INITIAL RECOMMENDATION OF THE EAST DESIGN REVIEW BOARD

Project Number: 3012797

Address: 802 Seneca Street

Date of Meeting: Wednesday, February 01, 2012

Alternative A

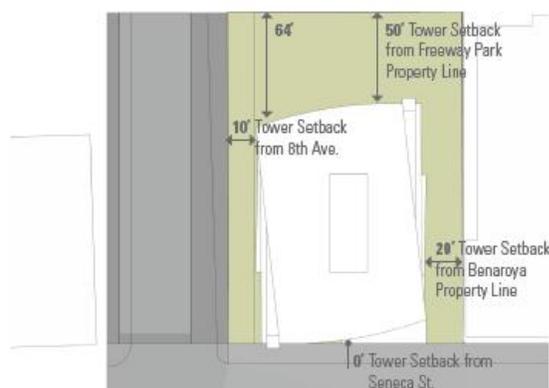
The first, and applicant-preferred scheme (Alternative A) showed a 300' tall tower located in the center of the site. Residential open space would be located at the north side of the site, level with Freeway Park, and at the rooftop. Potential materials included terracotta colored metal to respond to nearby brick and terracotta, light blue tinted glass, darker blue spandrel glass, and a mix of colors for the metal mullions. The benefits of this Alternative included a more slender tower and less building footprint than the approved MUP, more public open space at the street level, and an increased distance from the tower to the south (Royal Manor). Pros also included the ability to provide better storefront windows for the retail spaces at grade in a plaza setting, since the windows would not be cut off by the steep grades at street level. The setback from Seneca Street would allow for a better view of the Exeter House façade, as viewed from the east on Seneca Street. The applicant noted that a negative aspect of this setback is a lack of response to the context of nearby urban street walls.

Alternative C

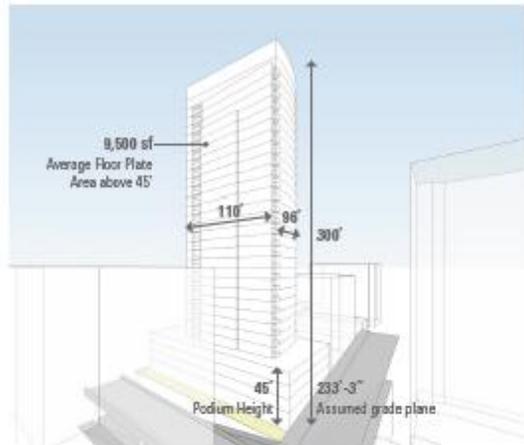
The third scheme (Alternative C) showed a tower centrally located above a 45' tall podium, as viewed from Seneca St. Pros included a response to the context of nearby street walls and a Land Use Code-conforming development. Cons included a lack of public open space at grade, reducing the view of Exeter House, a potential lack of cohesive design between the upper tower mass and the lower podium mass. Residential open space could be located at the top of the podium and the roof. This Alternative included 10 more parking spaces than Alternatives A and B.

- Alternative C is better because the street wall is a better response to nearby urban context, and the podium could offer an opportunity to design a street wall in scale with nearby context. The setback and open space alternatives are more suburban in nature and not appropriate for this site. The stepped plazas with planter walls separating sidewalk from plaza could lead to the plazas feeling proprietary rather than public.

Alternative D

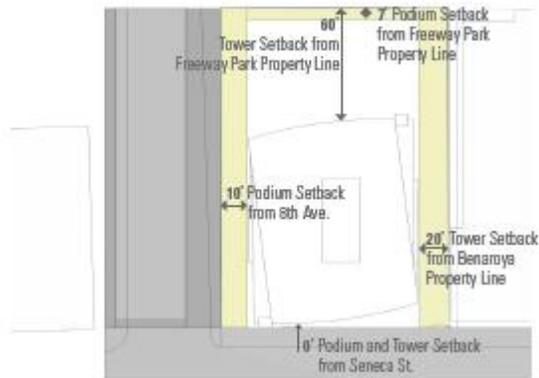
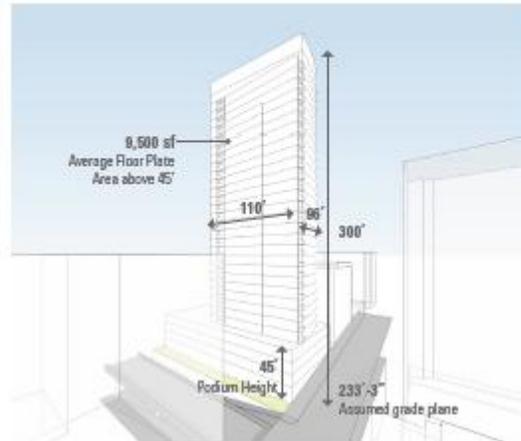
The fourth scheme (Alternative D) showed the same configuration as Alternative C, with the tower moved to the south property line. Increased parking was the same as in Alternative C. Pros and cons were listed as being the same as Alternative C.
